Errata sheet LPC82x

Rev. 1.1 — 18 November 2015

Info	Content
Keywords	LPC824M201JHI33; LPC822M101JHI33; LPC824M201JDH20; LPC822M101JDH20; LPC82x errata
Abstract	This errata sheet describes both the known functional problems and any deviations from the electrical specifications known at the release date of this document. Each deviation is assigned a number and its history is tracked in a table.

Fig 1. Incorrect setting of RXIDLE during UART receive

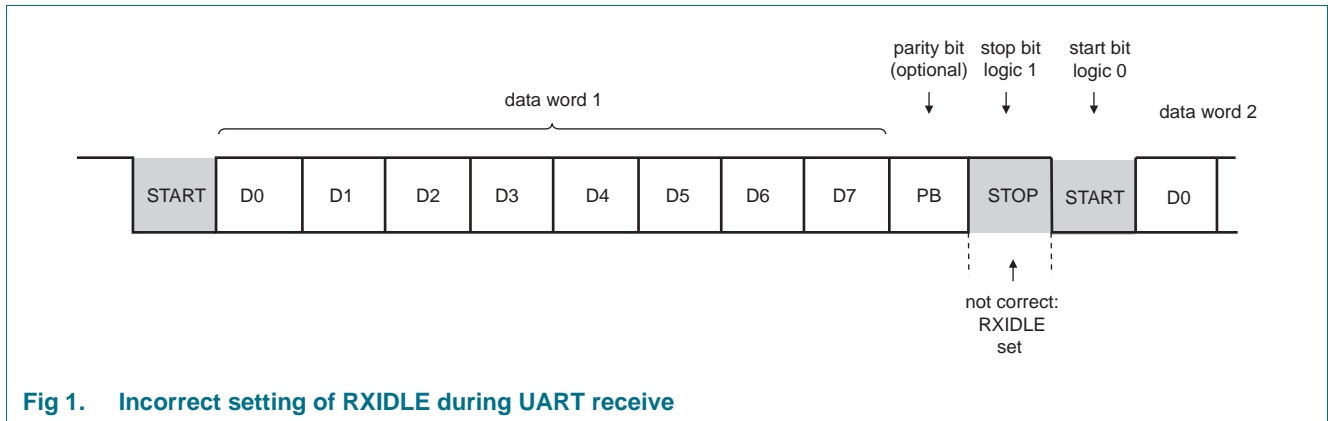
The RXIDLE bit is incorrectly set for a fraction of the clock cycle between the reception of the last data bit and the reception of the start bit of the next word, that is while the stop bit is received. RXIDLE is cleared at the beginning of the start bit.

When writing code that checks for the setting of any of the status bits RXIDLE, TXIDLE, TXDISSTAT, check the value of the status bit in the STAT register:

- If status bit = 1, add a delay of one UART bit time (if STOPLEN = 0, one stop bit) or two bit times (if STOPLEN = 1, two stop bits) and check the value of the status bit again:
 - If status bit = 1, the receiver is idle.
 - If status bit = 0, the receiver is receiving data.
- If the status bit = 0, the receiver is receiving data.

Fig 2. Incorrect setting of TXIDLE and TXDISSTAT during UART transmit

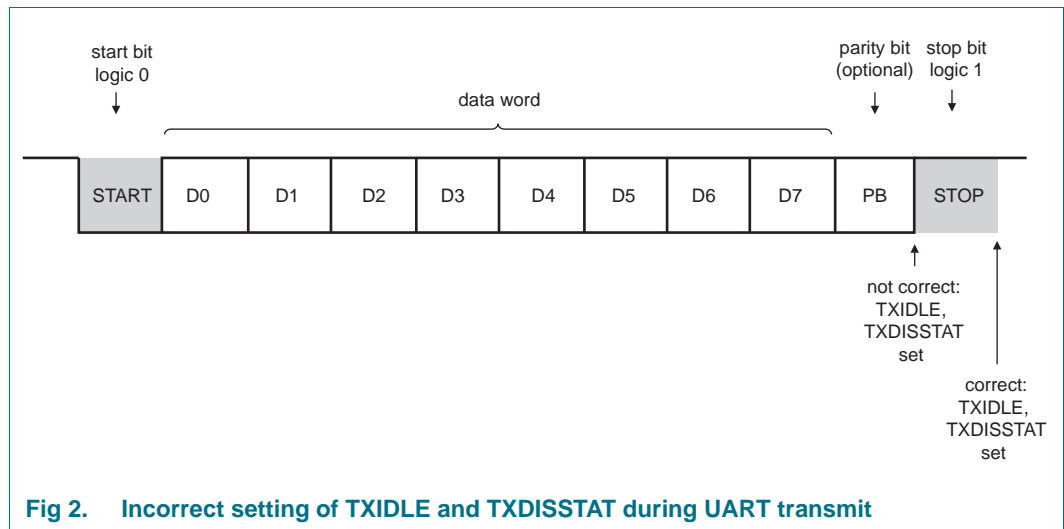
Both, TXIDLE and TXDISSTAT are set incorrectly between the last data bit and the stop bit while the transfer is still ongoing.
